PD Modification Application PRS 22-1093

**Hillsborough
County Florida**

Request: Minor Modification to PD 1110

AGENCY REVIEW COMMENT SHEET

2.5 Proposed Site Plan

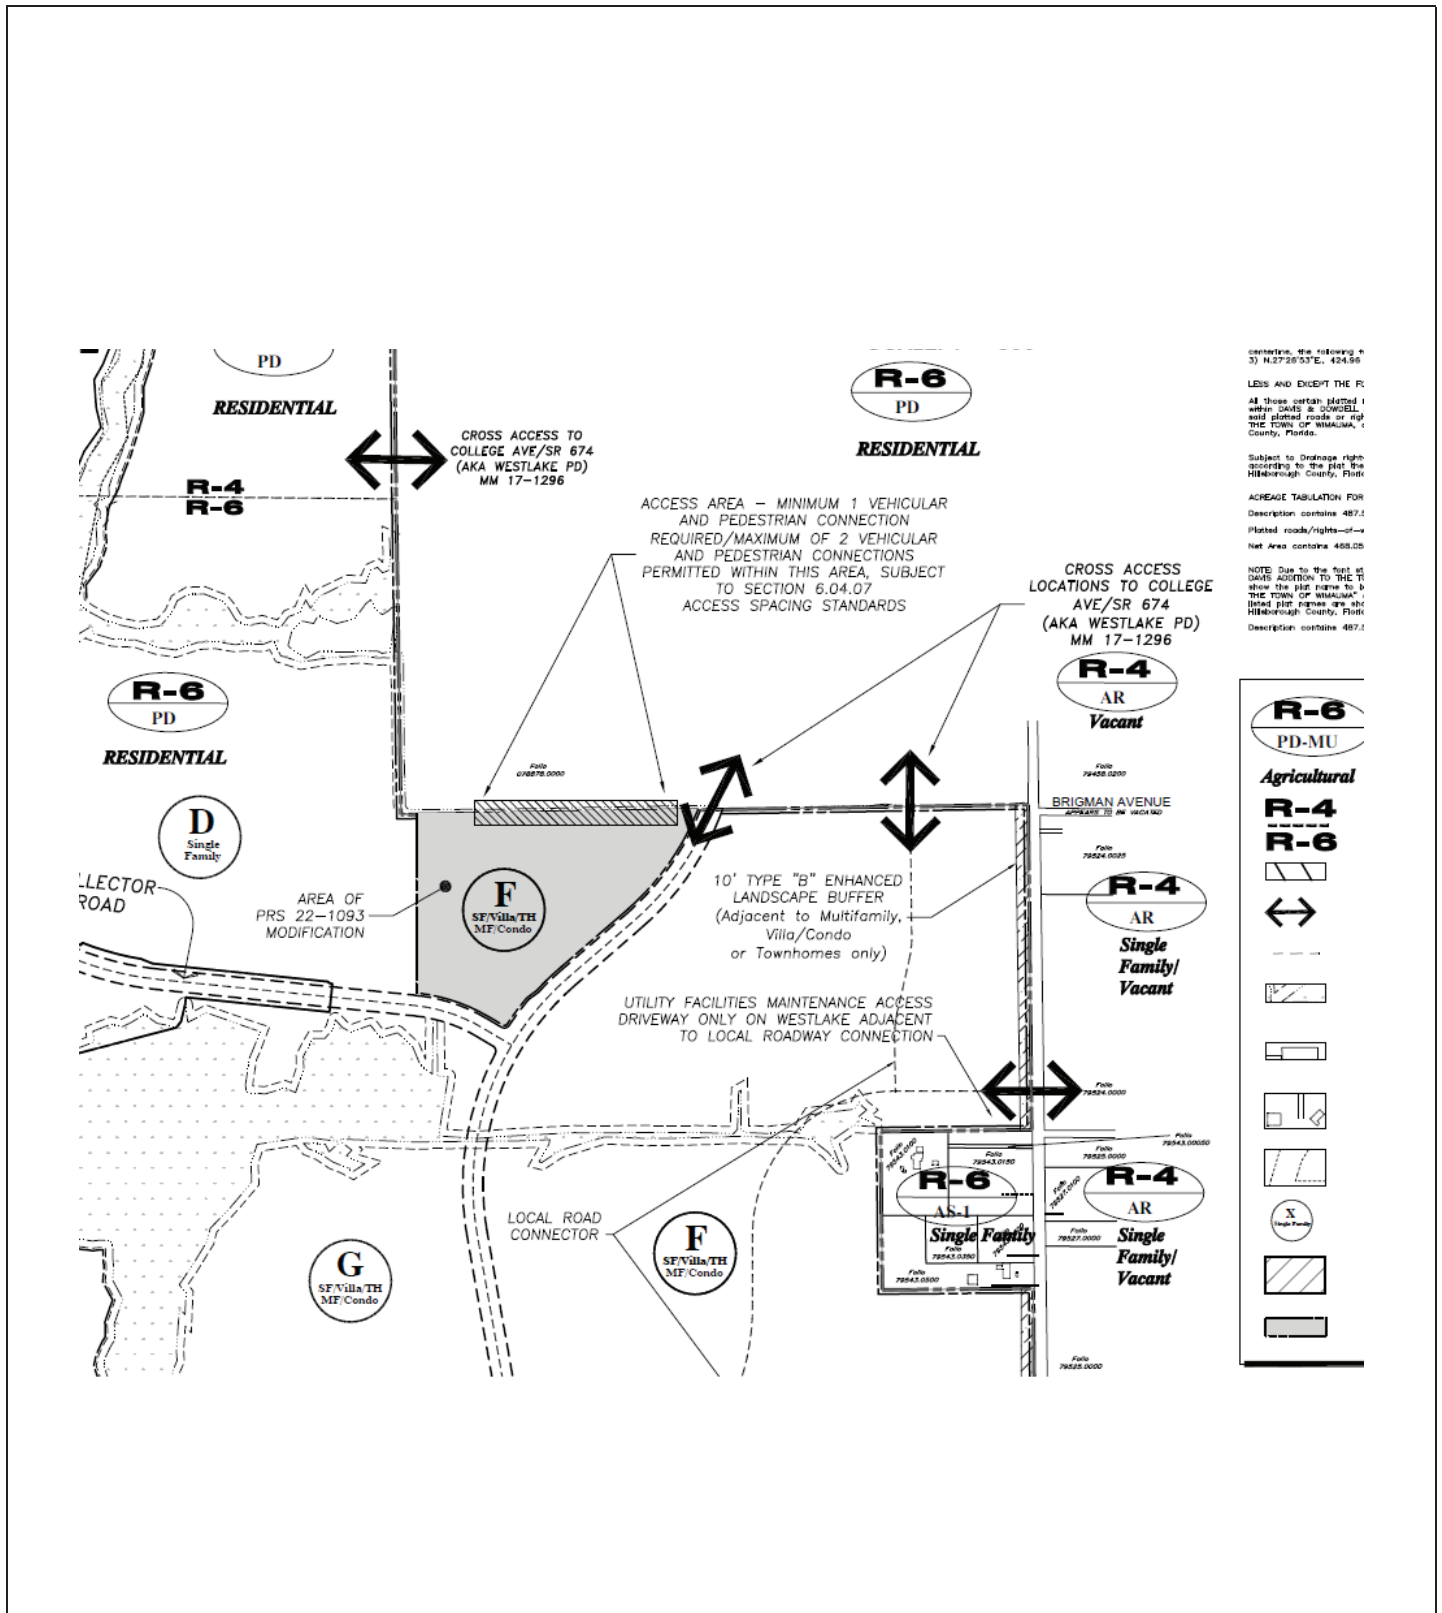
The access relocation will have minimal impact on the transportation network. Transportation Review staff offered no objection to the proposed access points relocation, subject to the revised conditions as outlined in the conditions of approval.

The area of modification will take primary access to Lagoon Shore Blvd. Additional vehicular and pedestrian connection is provided for along the northern boundary. The proposed PD site plan modification shows a general access area along the northern boundary. The proposed general access area is intended to provide flexibility, both

in the number (up to a maximum of two) and location of potential access points, to coordinate alignment with the adjacent PD's access points at the time of subdivision/site plan approval.
